RE: Jennesstown Manor Site Plan Application
Tax Map 7, Lots 39 & 39-1 – Warner

Our office is in receipt of the Aries Engineering review comments dated Oct. 20, 2025, and the Fire Department comments dated July 6, 2025. Based on the comments, we have made the required modifications and attached revised plans for review. A response to each comment has been provided below.

Aries Engineering Review Comments, dated October 20, 2025

LANDSCAPE PLAN

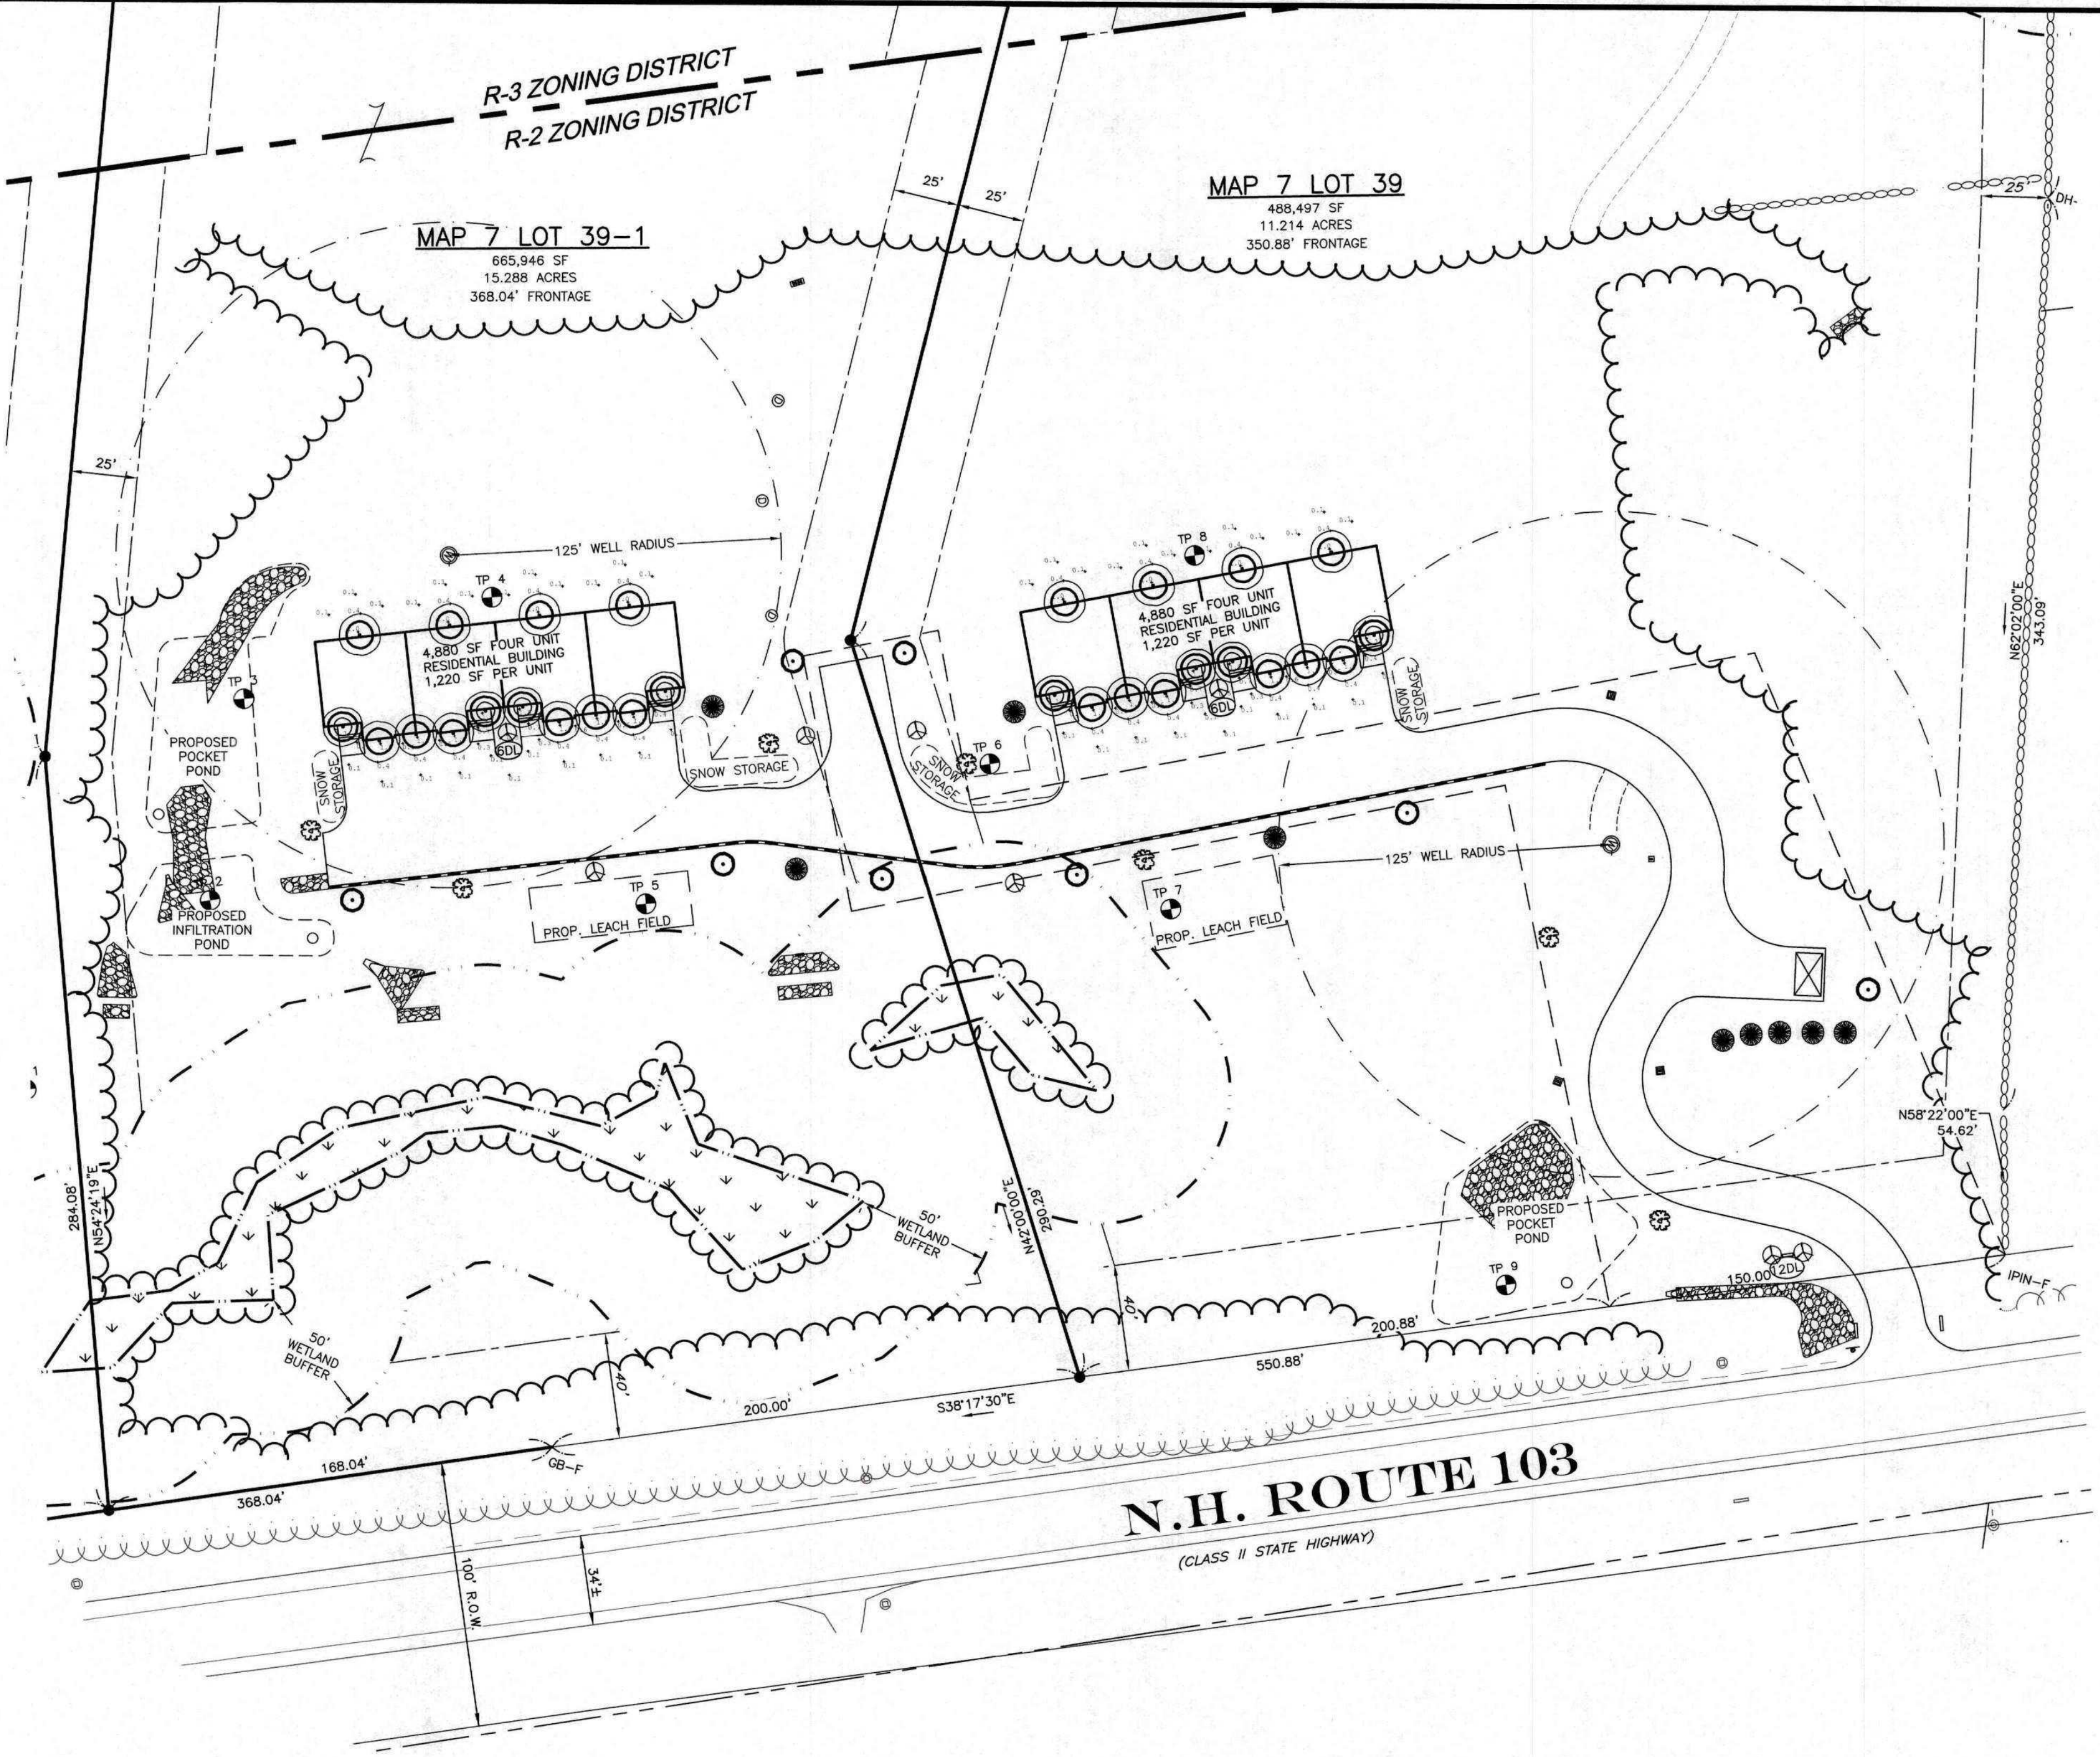
20. Section XVII - Landscaping Standards require a minimum of one 2-1/2" caliper deciduous tree for every 20 parking spaces and every 60 feet of access roads. Available Landscape Plan details list only three deciduous trees to be planted, which does not meet the Town's Landscaping Standards.

The landscape calculations for the deciduous trees have been added to Sheet 7. Twelve additional trees have been added to the plan.

DRIVEWAY PROFILE PLAN JENNESSTOWN MANOR MAP 7, LOTS 39 & 39-1 ROUTE 103 WARNER, NEW HAMPSHIRE MERRIMACK COUNTY

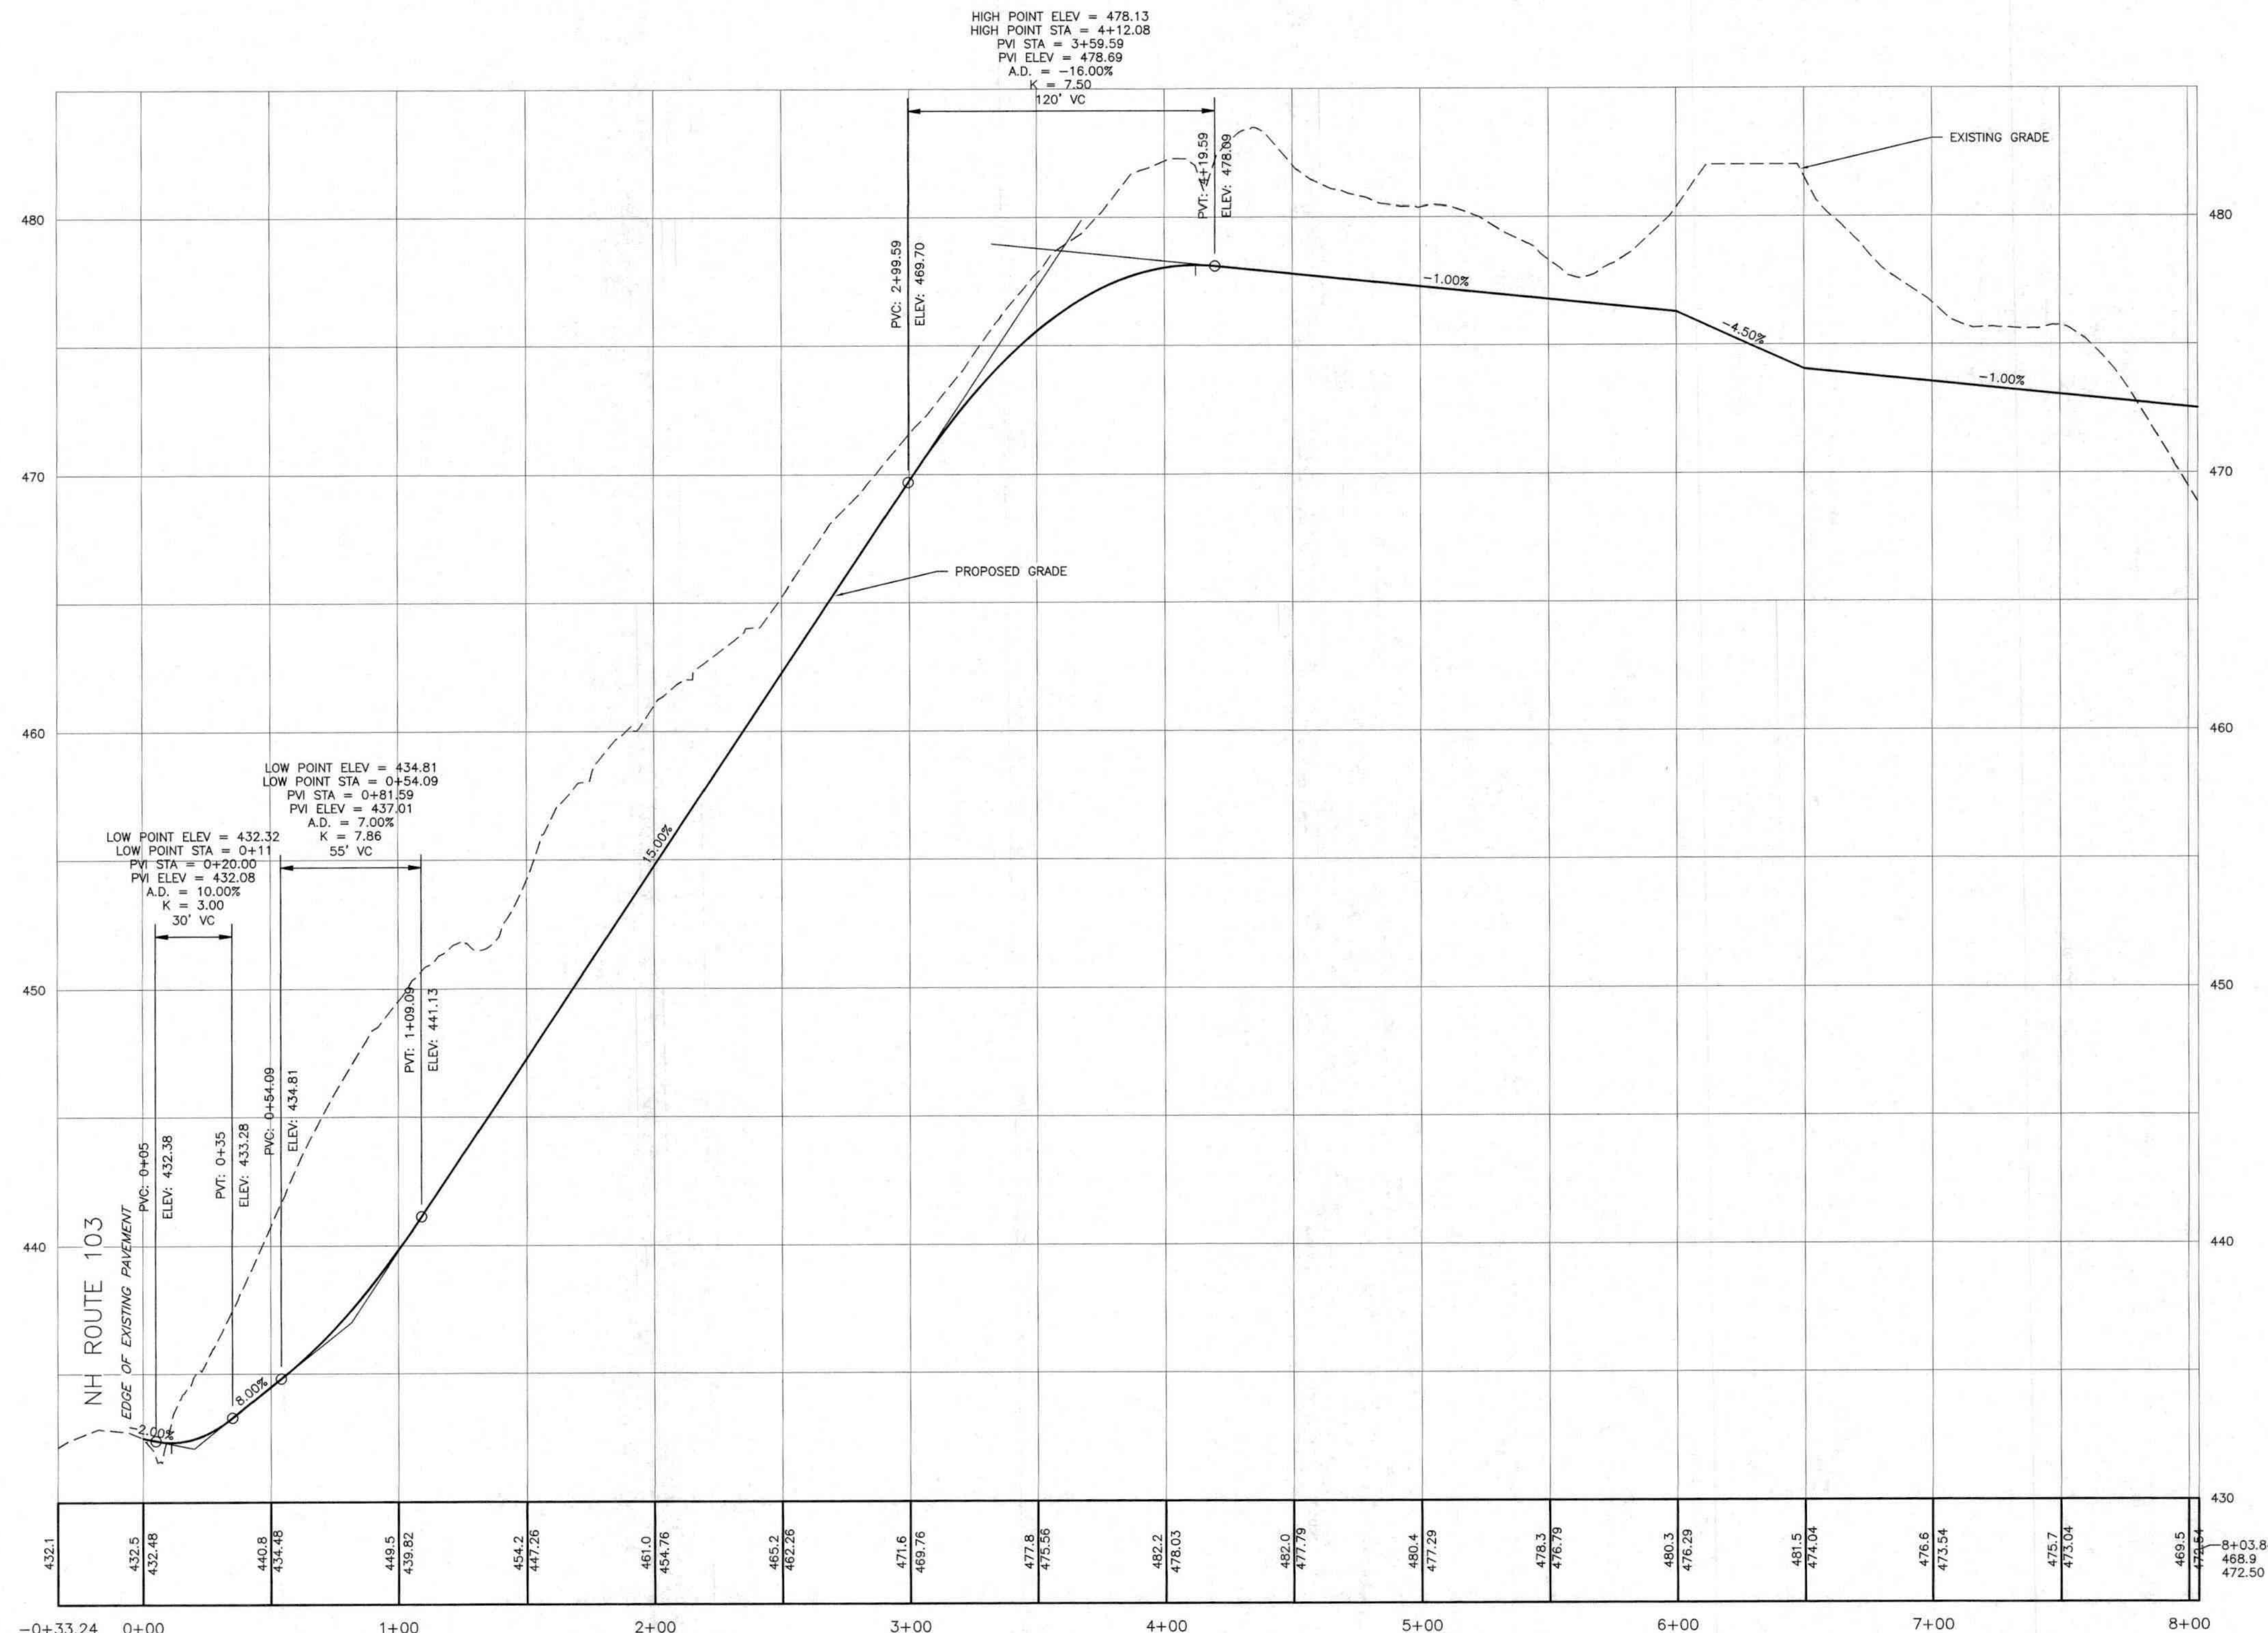
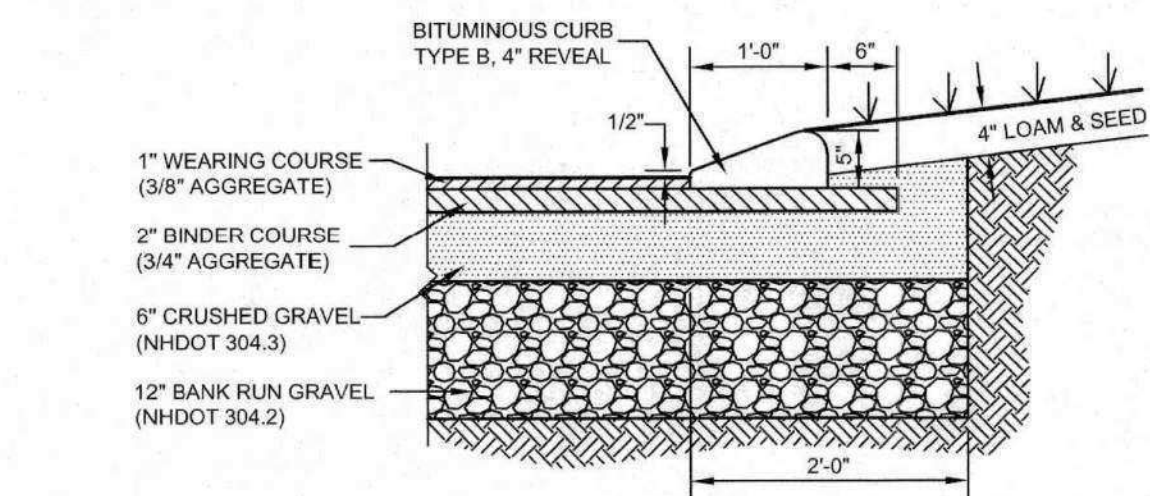
6. The site plans indicated an approximate access road starting elevation of 433 feet and a high point elevation of approximately 478 feet for the site access road, which is approximately 420 feet in length. The average grade is approximately 10.7%, while the majority of the access road is at a grade of 14.26%. Aries recommends that the proposed site access road be lengthened to meet the Section VII Design Standards grade of 10% for a local street for all portions of the access

As can be seen on Sheet 11, the centerline profile of the driveway transitions from a -2% grade, to a +8% grade to a +15% grade. Between each change in slope a transition vertical curve has been added. This permits the appropriate platform adjacent to the roadway. To reduce the grade from 15% to the suggested 10.7% grade the point of vertical curve at the top of the “hill” would result in an additional 12 foot cut into the slope. This would also cause the structures to be about 10 lower. We have chosen to hold the 15% grade outlined in the driveway regulations to minimize the cuts and constructability of the project. No modification has been made.

OUTLET CONTROL STRUCTURE #41P DETAIL
NOT TO SCALE

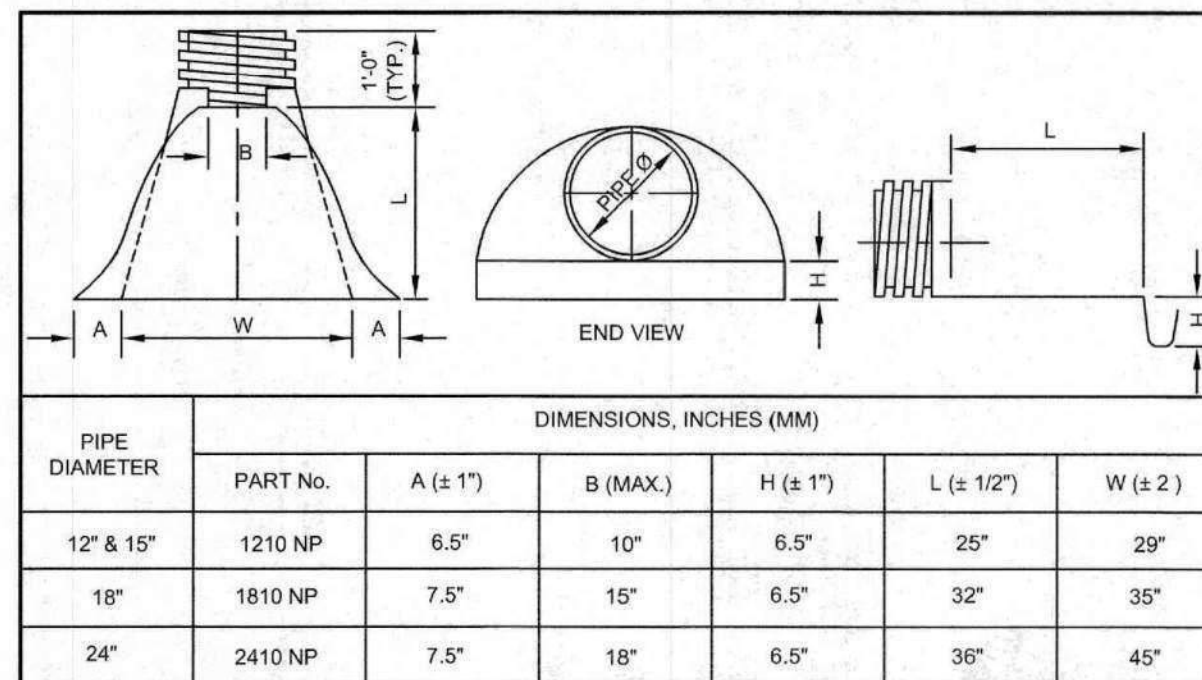
17. Lastly, the groundwater discharge from OCS#41 will increase the volume of water discharge to the State Right-of-Way (ROW), where it will flow to catch basing CB#4 and be directed beneath Route 103 through an existing 15-inch reinforce concrete pipe (RCP) culvert. This additional contribution of groundwater is not accounted for in the KNA drainage model and report. However, this additional discharge should not affect the northwesterly abutting property.

18. Aries recommends that the stormwater storage in Pocket Pond #41 be evaluated and redesigned to provide adequate stormwater storage and to mitigate groundwater discharge.

Groundwater discharge is a valid point. Groundwater will be dependent on subsurface water levels and seasonal conditions. Groundwater flow is factor separate from the storm event evaluated by the analysis. Groundwater is potentially flowing while it is not raining.

As previously outlined above, the design complies with the design requirements of NHDES Env-Wq 1500. Further the design has been reviewed by NHDES Alteration of Terrain and did not receive comments to revise the design. No modifications have been made.
